Submission of Further Information

**Proposed Temporary Warehouse (excluding Dangerous Goods Godown) with
Ancillary Office and associated Filling of Land for a Period of 3 Years
Lots 29 (Part), 33 (Part) and 35 (Part) in D.D. 111
and Adjoining Government Land, Pat Heung, Yuen Long
(Application No.: A/YL-PH/1077)**

Comments from Drainage Services Department dated 30.1.2026

Plan 6.3
(P 25025)

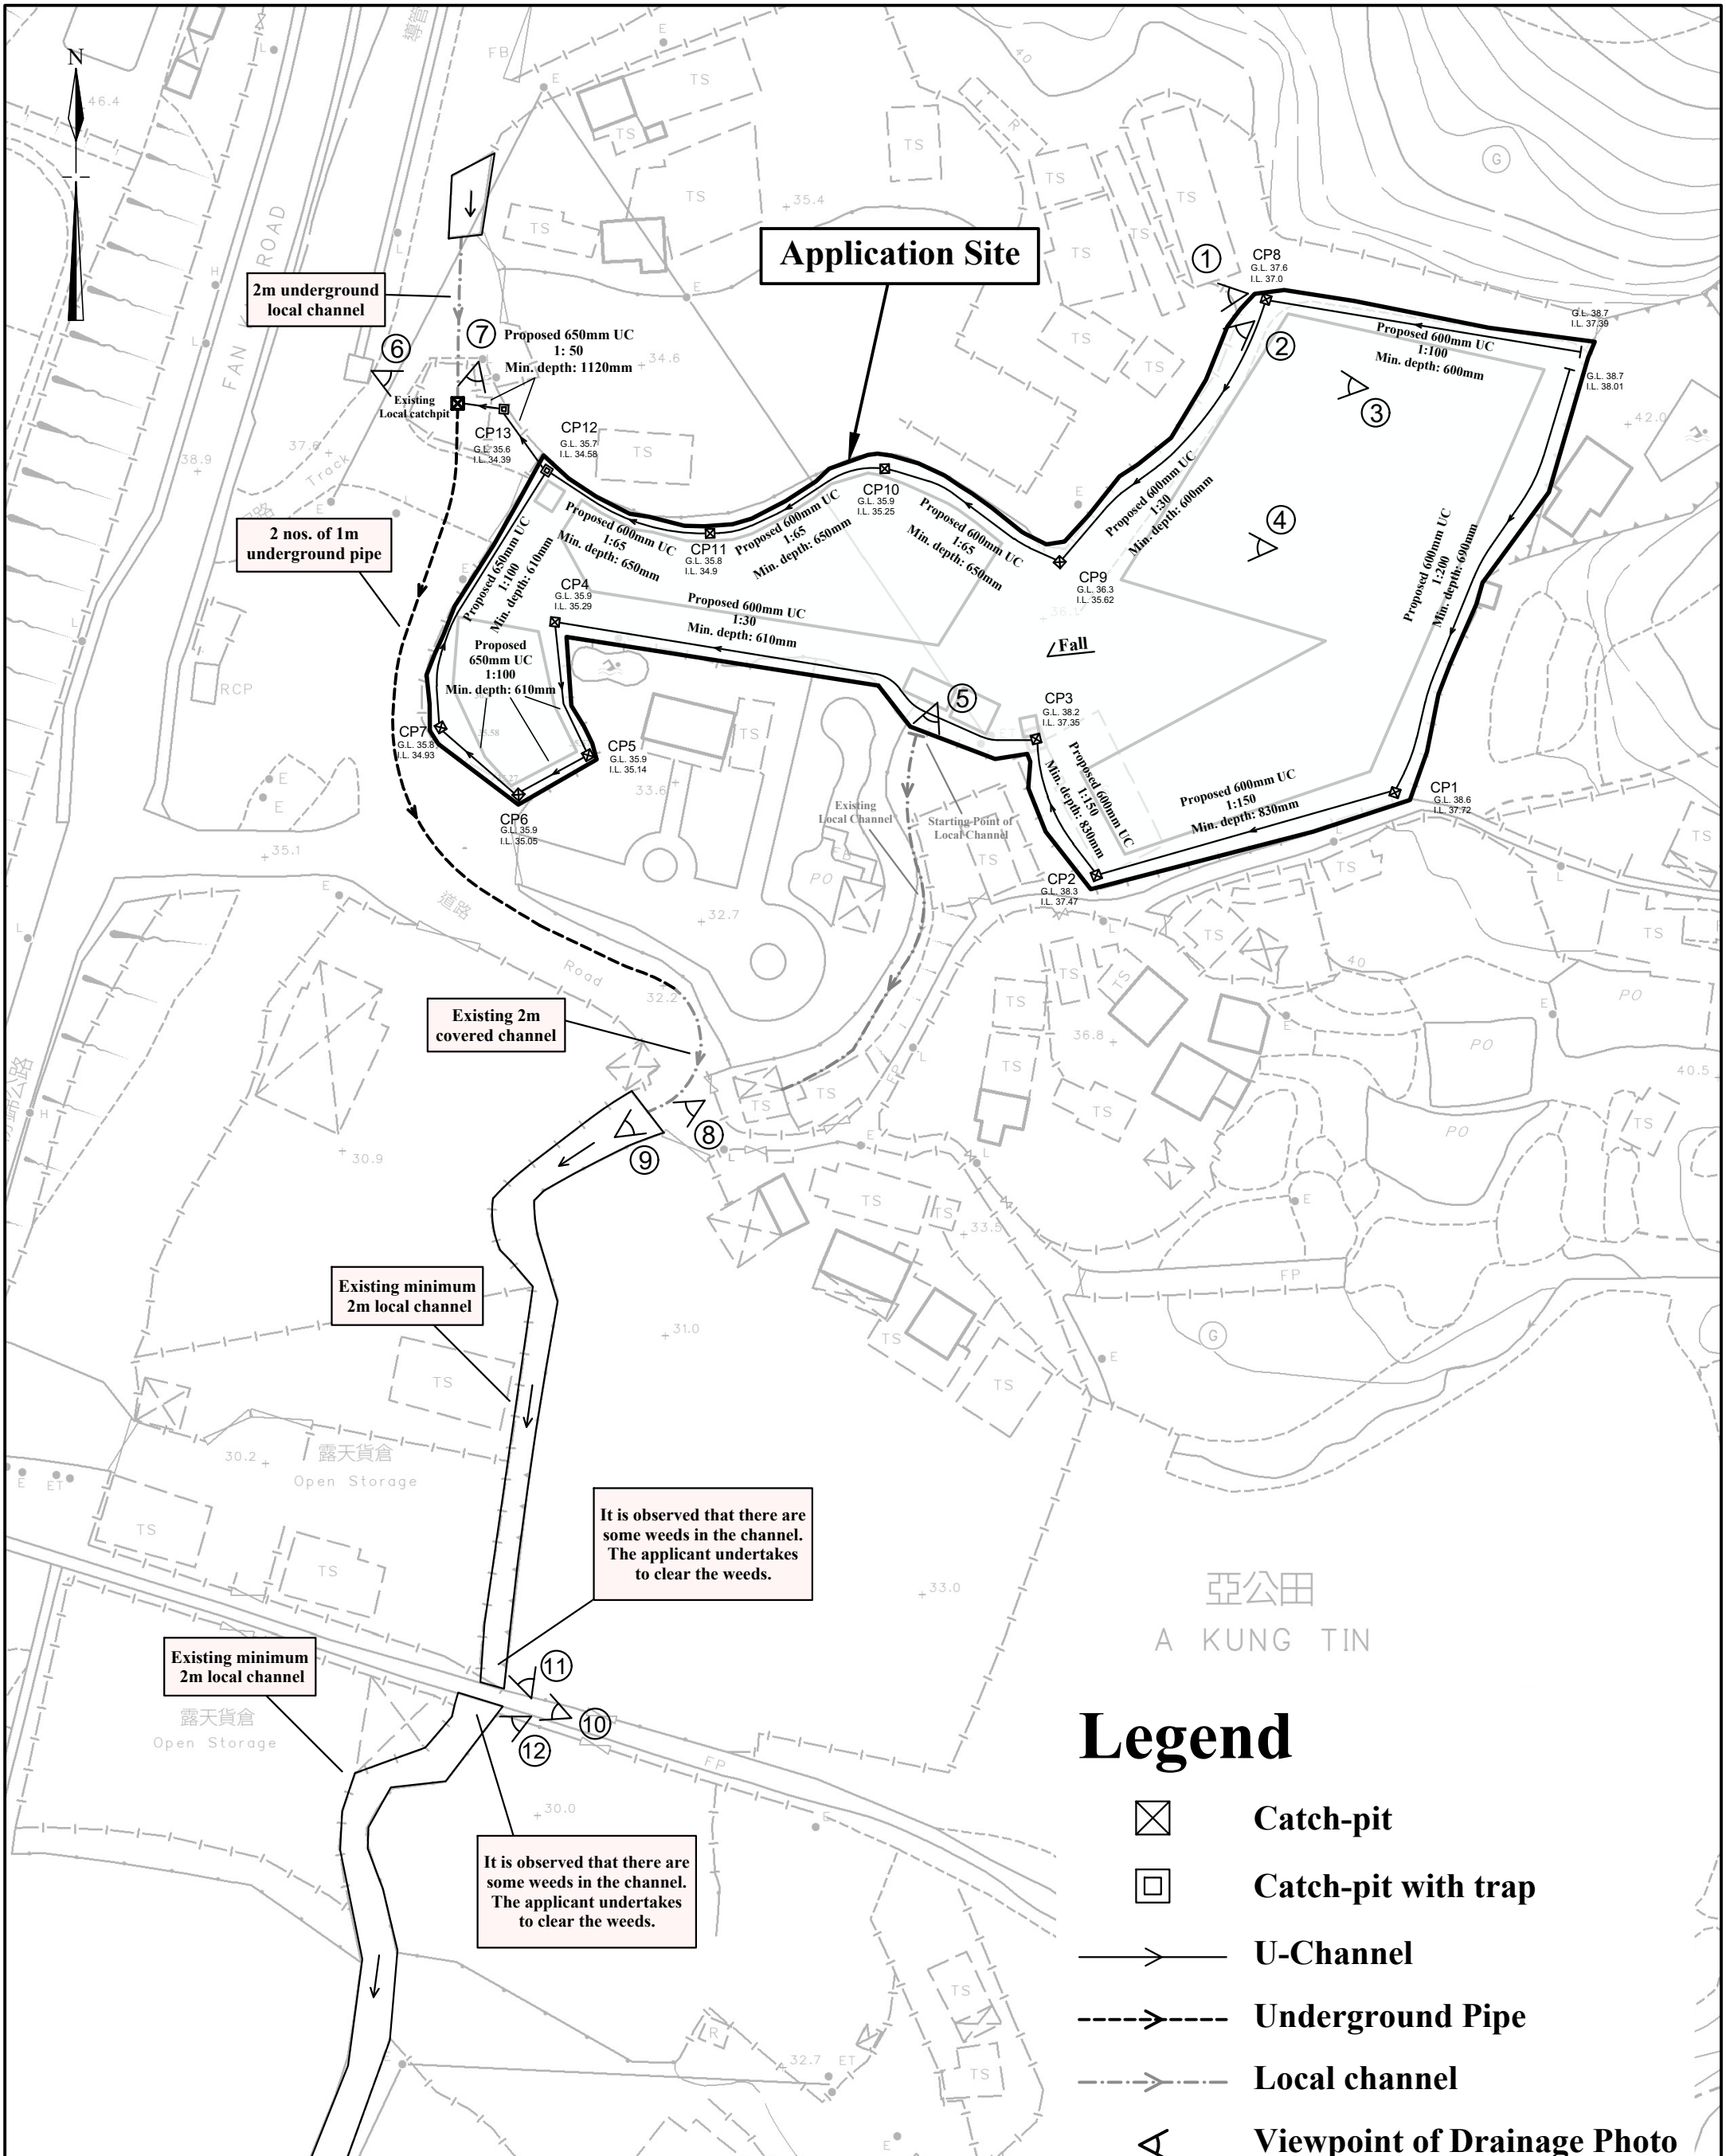
Comments	Responses																																												
i.	The hydraulic capacity of the proposed downstream facility (from CP12 to the existing underground pipe - 600mm u-channel at 1:100) should be larger than the upstream ones. (from CP11 to CP12 - 600mm u-channel at 1:50). A similar case is also happened for the proposed drainage facility from CP3 to CP4 - 600mm u-channel at 1:30. Please review the size and gradient of the proposed drainage facility at downstream.	<p>The u-channels after CP4 are upgraded to 650mm u-channels. The hydraulic capacity of the proposed downstream facility is larger than the upstream. The hydraulic capacity is as follows:</p>

Comments	Responses
		Please refer to Hydraulic Calculation Page 1 to Page 8 for reference. The hydraulic capacity of the drainage facilities is underlined.
ii.	Please indicate clearly the full alignment of the discharge path from the application site all the way down to the ultimate discharge point (e.g. a well-established stream course/public drainage system) for the existing underground pipe and provide site photos to demonstrate its presence and existing condition at downstream.	<p>Please refer to Plan 6.3 showing the viewpoints of photographs and attached drainage photographs.</p> <p>It is observed that there are some weeds in the channel downstream (Viewpoints 11 and 12). The applicant undertakes to clear the weeds.</p>
iii.	The development should neither obstruct overland flow and nor adversely affect existing natural streams, village drains, ditches and the adjacent areas, etc.	Noted.

<table><tr><th>Section of U-channel</th><th>Specification of U-channel</th><th>Capacity</th><th>Capacity larger than Upstream?</th></tr><tr><td>Before CP1</td><td>600mm UC 1:200 min. depth: 690mm</td><td>0.820 m³/s</td><td>Yes</td></tr><tr><td>CP1-CP3</td><td>600mm UC 1:150 min. depth: 830mm</td><td>0.907 m³/s</td><td>Yes</td></tr><tr><td>CP3-CP4</td><td>600mm UC 1:30 min. depth: 610mm</td><td>1.318 m³/s</td><td>Yes</td></tr><tr><td>CP4-CP12</td><td>650mm UC 1:100 min. depth: 610mm</td><td>1.740 m³/s</td><td>Yes</td></tr><tr><td>Before CP8</td><td>600mm UC 1:100 min. depth: 600mm</td><td>0.704 m³/s</td><td>Yes</td></tr><tr><td>CP8-CP9</td><td>600mm UC 1:30 min. depth: 600mm</td><td>1.529 m³/s</td><td>Yes</td></tr><tr><td>CP9-CP12</td><td>600mm UC 1:65 min. depth: 650mm</td><td>1.925 m³/s</td><td>Yes</td></tr><tr><td>After CP12</td><td>650mm UC 1:50 min. depth: 1120mm</td><td>2.973 m³/s</td><td>Yes</td></tr></table>

Viewpoint 10

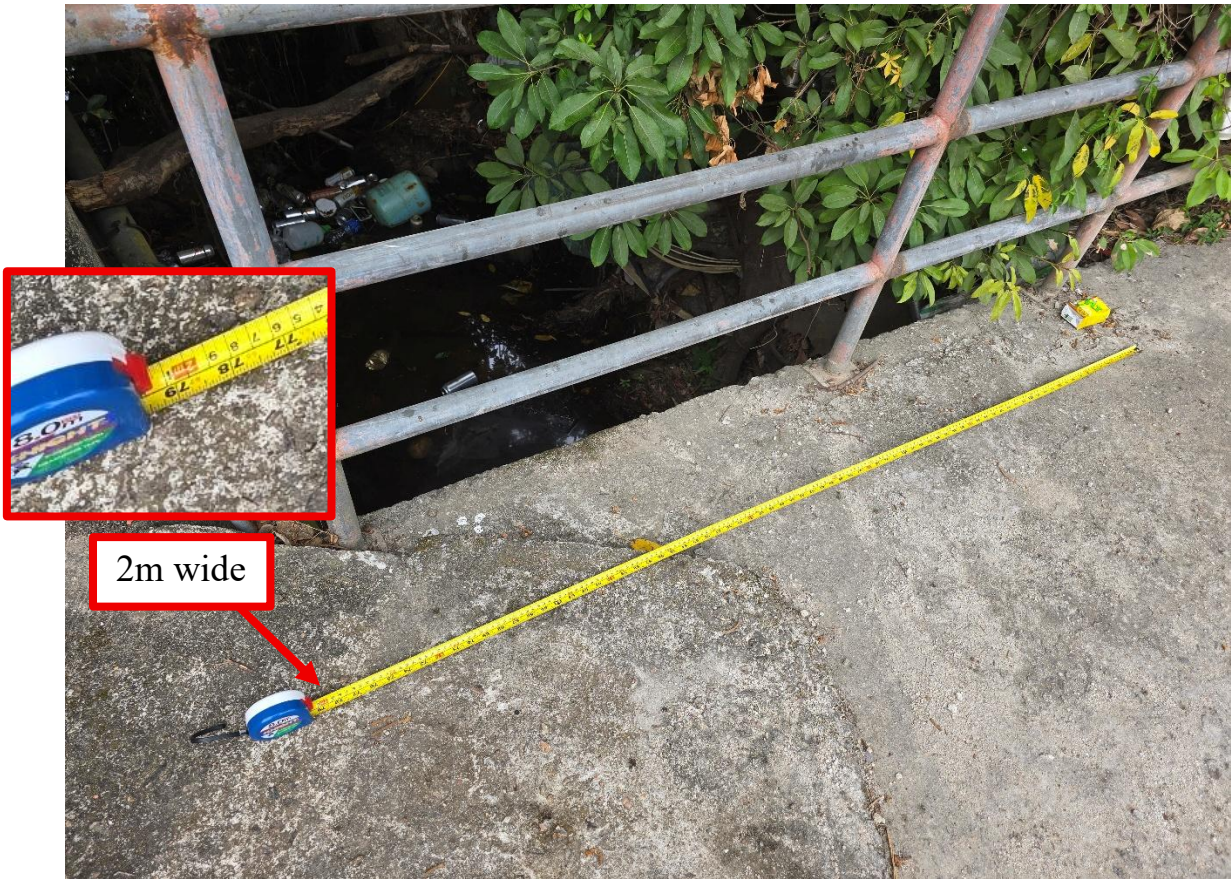
It is noted that there are some overgrown vegetations and silting in the downstream channel outside the site (see Plan 6.3 and viewpoints 10-12). The applicant undertakes to clear these overgrown vegetation and silting.
